Subject: GLOW AROUND WIPER SWITCH REWORK WIPER SWITCH BEZEL

Model and Year: 1981 Corvette

Bulletin Number: 81-I-19

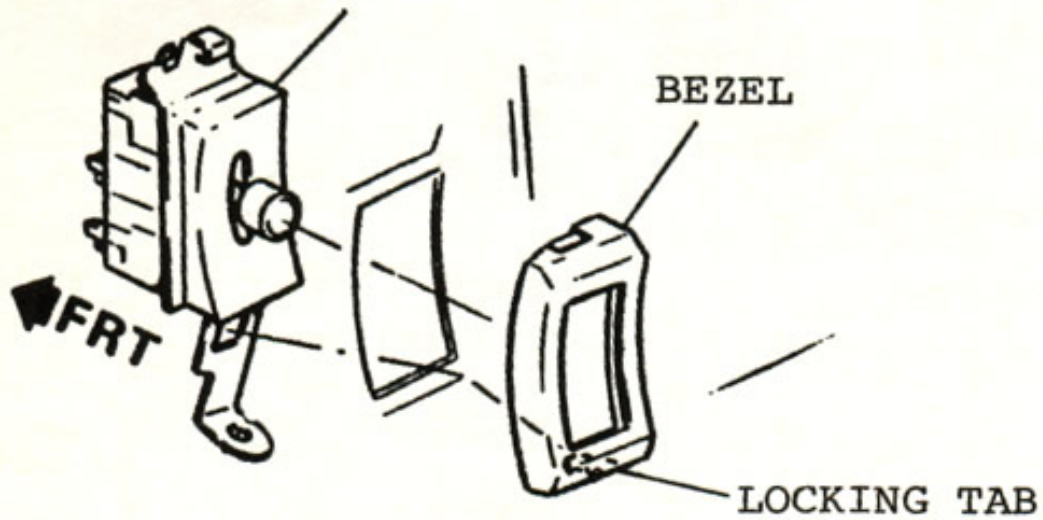
SOME EARLY 1981 CORVETTES WITH SILVER, RED, OR RUST TRIM MAY EXHIBIT A GLOW AT NIGHT AROUND THE WIPER SWITCH BEZEL. IN THESE COLORS, THE BEZEL BASE MATERIAL IS "NATURAL" AND COULD BECOME TRANSLUCENT WITH LIGHTS TURNED ON. THE REMAINING BEZEL COLORS WERE PAINTED OVER A BLACK BASE MATERIAL AND ARE NOT AFFECTED.

THE GLOWING CONDITION CAN BE ELIMINATED BY REPLACING THE ORIGINAL BEZEL WITH P/N 14016216, WHICH IS BLACK AND MUST BE PAINTED TO MATCH TRIM COLOR. THE BEZEL HAS A LOCKING TAB WHICH ENGAGES THE WIPER SWITCH AS ILLUSTRATED ON PAGE 2.

CORVETTE WIPER SWITCH BEZEL ATTACHMENT

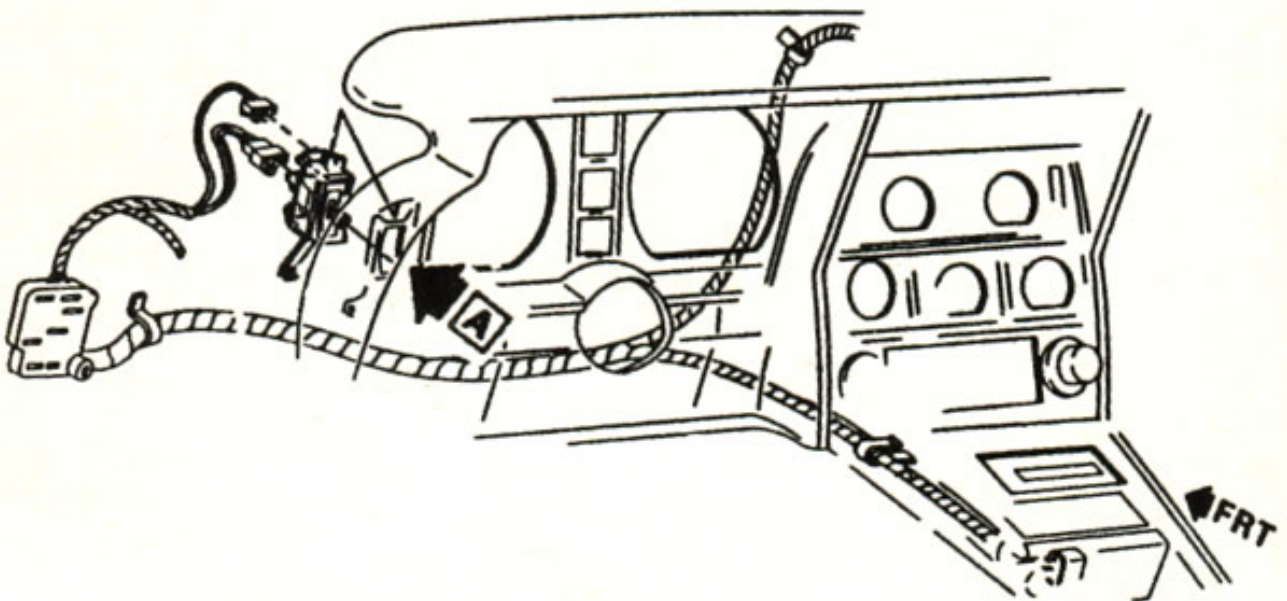
REPLACEMENT REQUIRES SETTING THE STEERING COLUMN TO ITS LOWEST TILT POSITION, REMOVING THE SPEEDOMETER CLUSTER, AND REACHING THROUGH THE INSTRUMENT PANEL TO DISCONNECT THE BEZEL LOCKING TAB.
